HOPEWELL TOWNSHIP HEALTH DEPARTMENT

RE: Block 62, lot 4.01 (1262 Bear Tavern Road)

Re: Sewage Disp. Application

SEWAGE DISPOSAL SYSTEM FOR

Construction
 Block 62
 LOT 4-01
 No exterior changes.
Owner

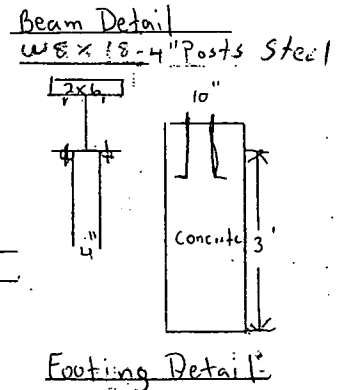
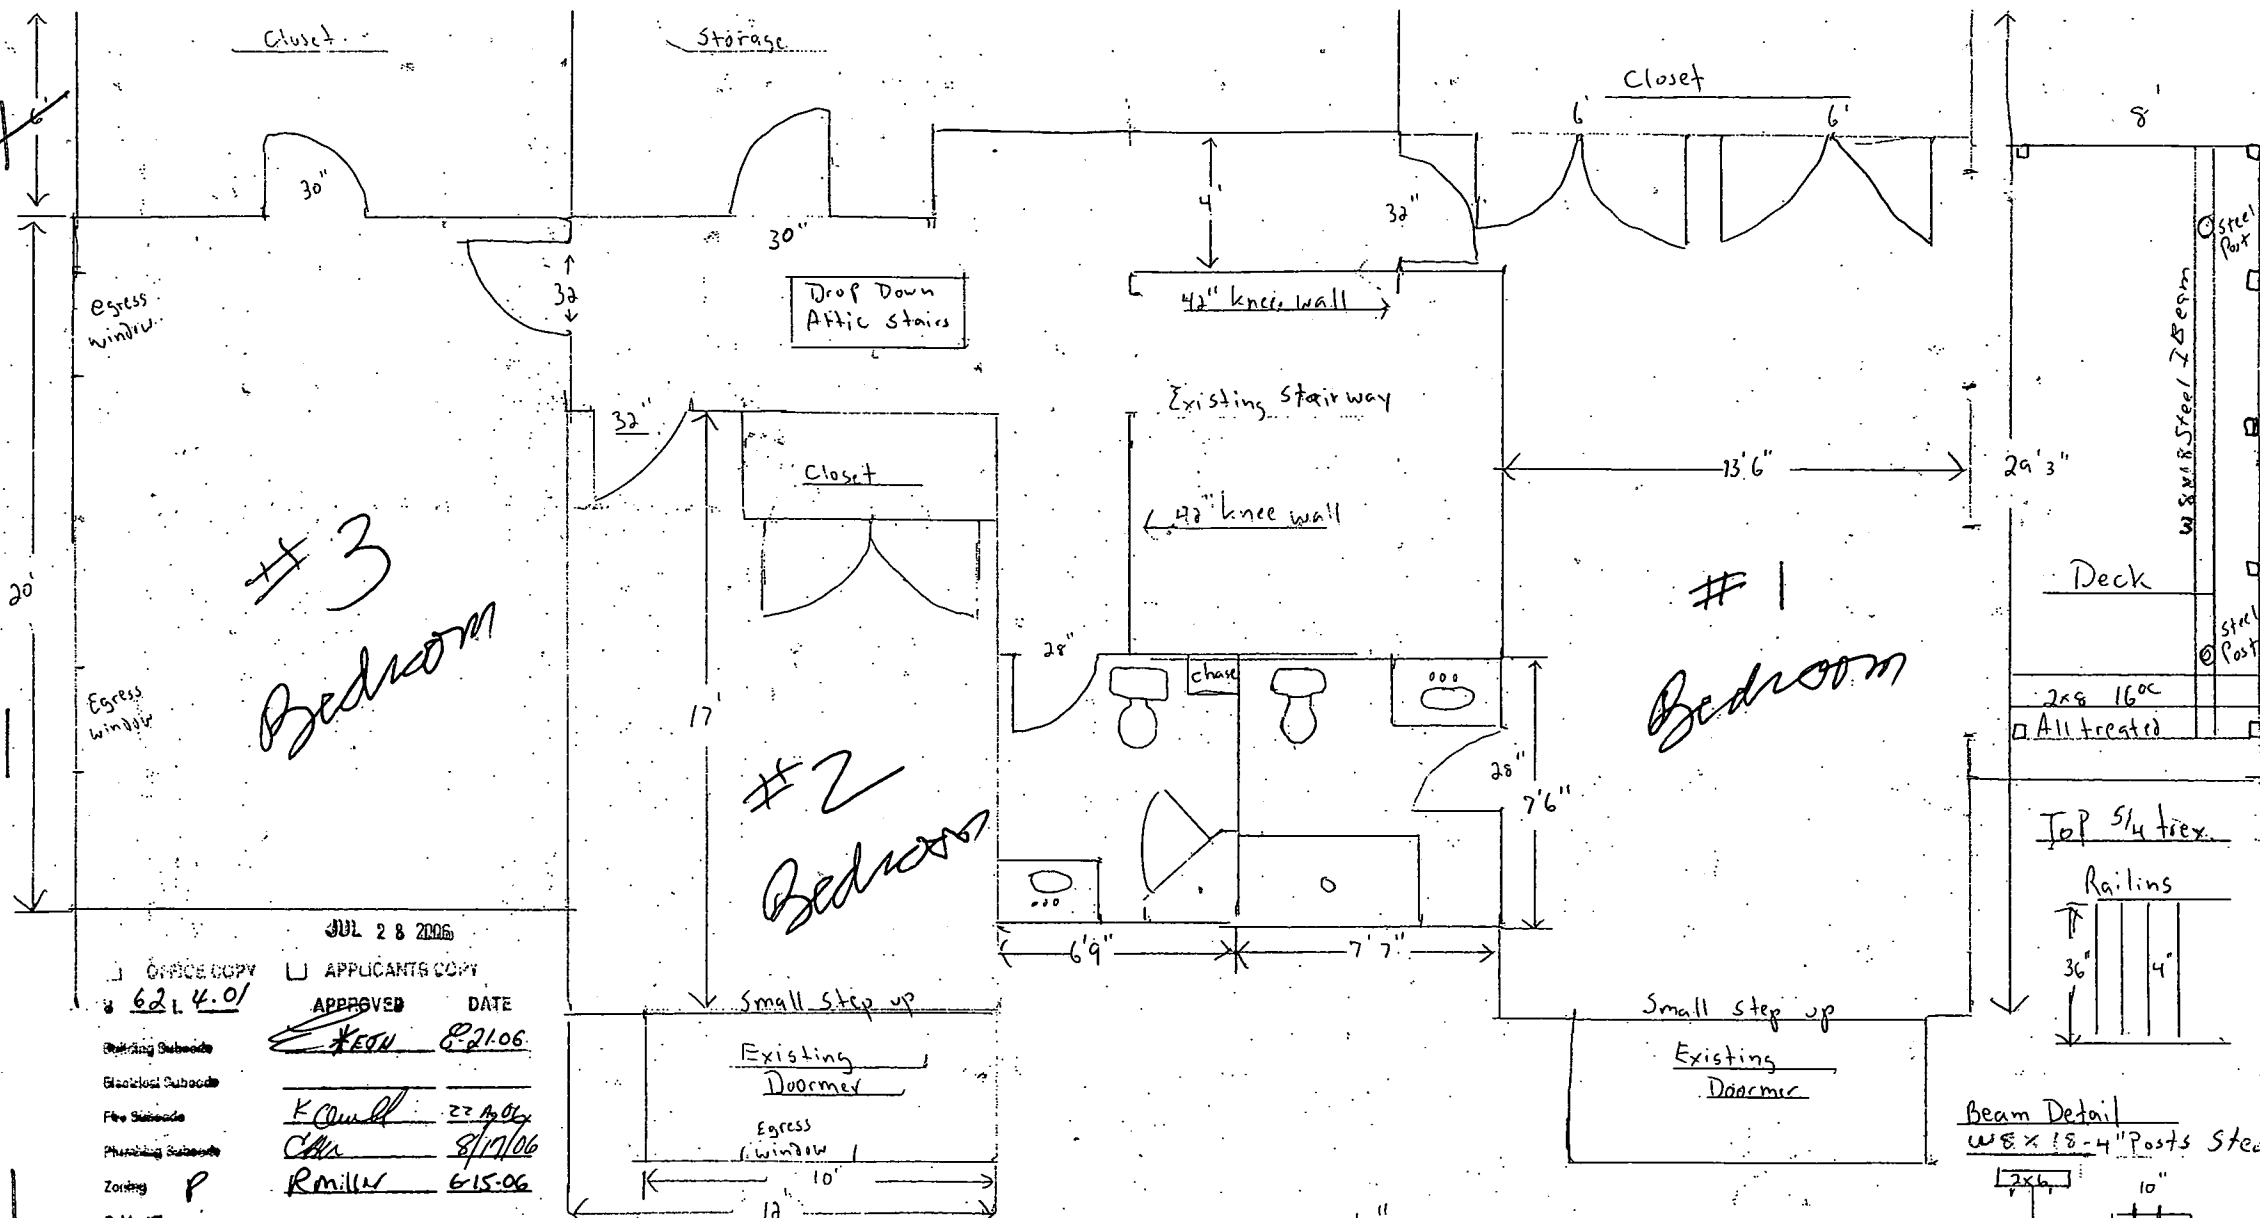
This office has received your construction application for Health Department review and cannot determine the total number of bedrooms in the above referenced property from the information provided. The following information must be provided to this Department for review:

1. A floor plan of the existing dwelling prior to renovation. (Floor plans need not be architectural drawings, but must show layout of all floors and indicate room dimensions)
2. A floor plan of the dwelling as it will appear after completion of the proposed project.

N.J.A.C. 7:9A, Standards for Individual Subsurface Sewage Disposal Systems indicates the volume of sanitary sewage generated from a private residence shall be estimated based on the number of potential bedrooms in the dwelling. The existing septic system was designed and approved based on the number of potential bedrooms constructed in the house. An increase in the number of bedrooms in an existing house, via renovations, requires a review of the existing septic system capacity. Also, increasing the number of bedrooms in a house may require the homeowner to increase the capacity of the septic system. Our records indicate this dwelling currently has four (4) bedrooms.

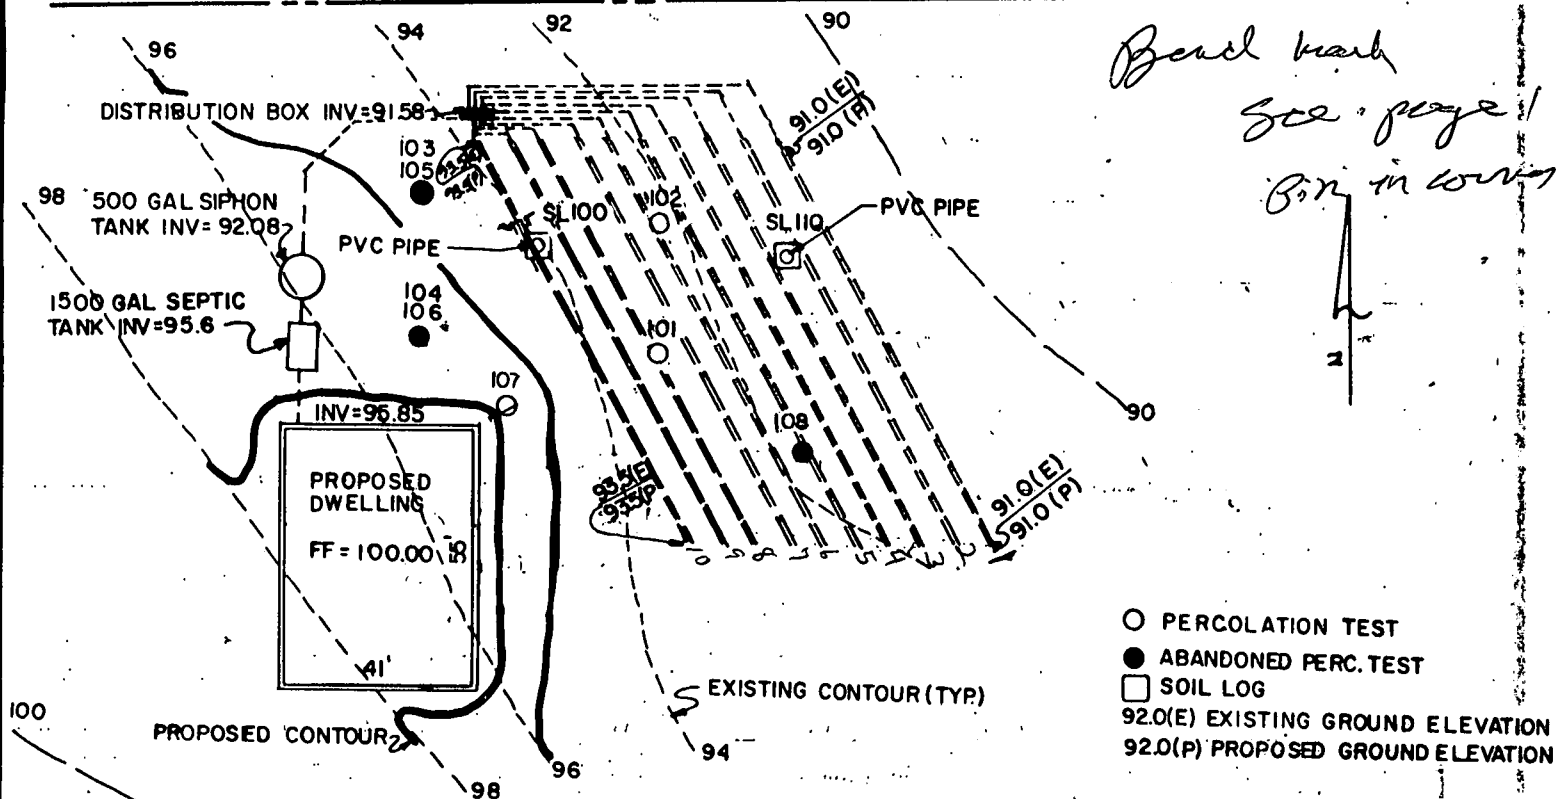
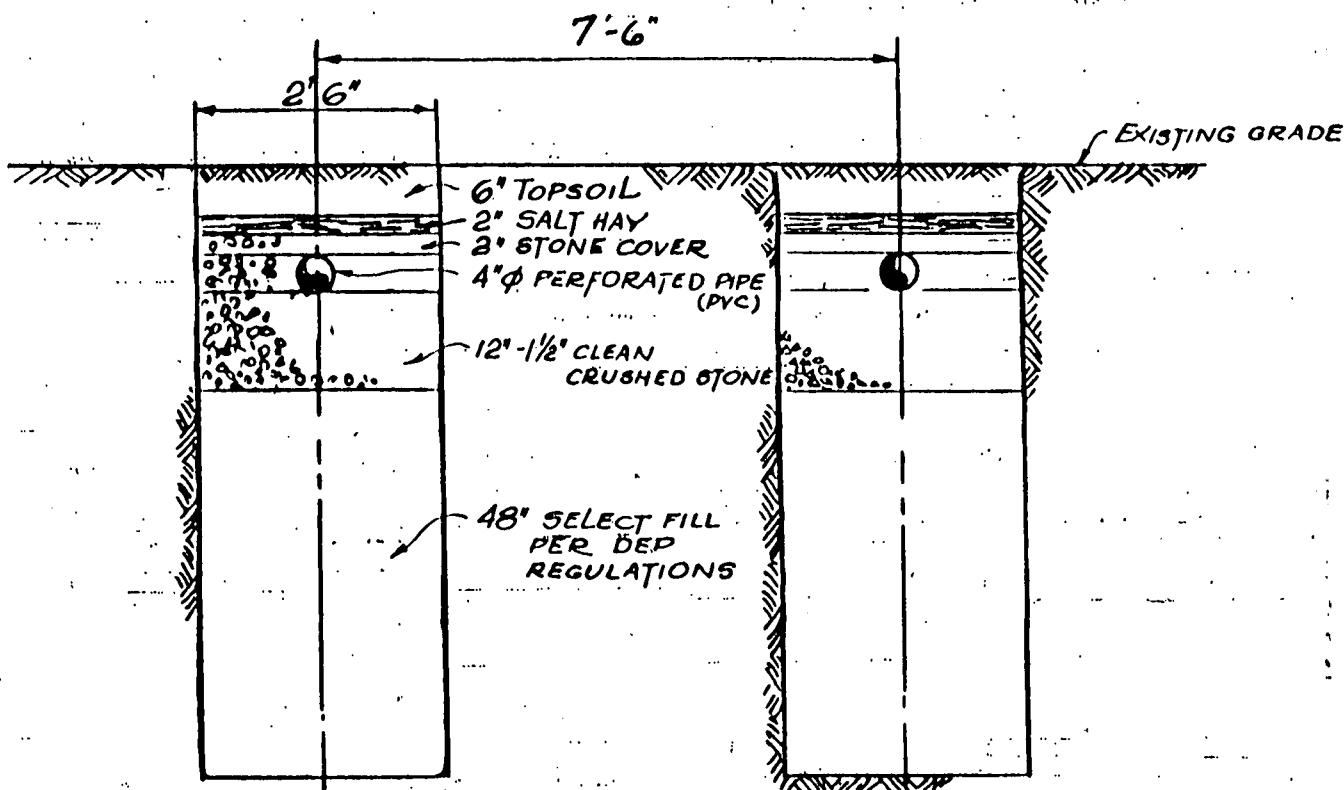
Your application for an individual sewage disposal system for the subject property has been reviewed by this office and must be denied for the following:

1. System not designed to minimum square footage required by Township Ordinance.
2. Based on a design rate of 55 min/inch, trenches must be 7.5 feet on center
3. Over 600 linear feet of distribution line requires mechanical dosing or siphon.

2-12-88 REV PER HOPEWELL TOWNSHIP
HEALTH DEPT.
2-23-88 REV PER TOWNSHIP
HEALTH DEPT.
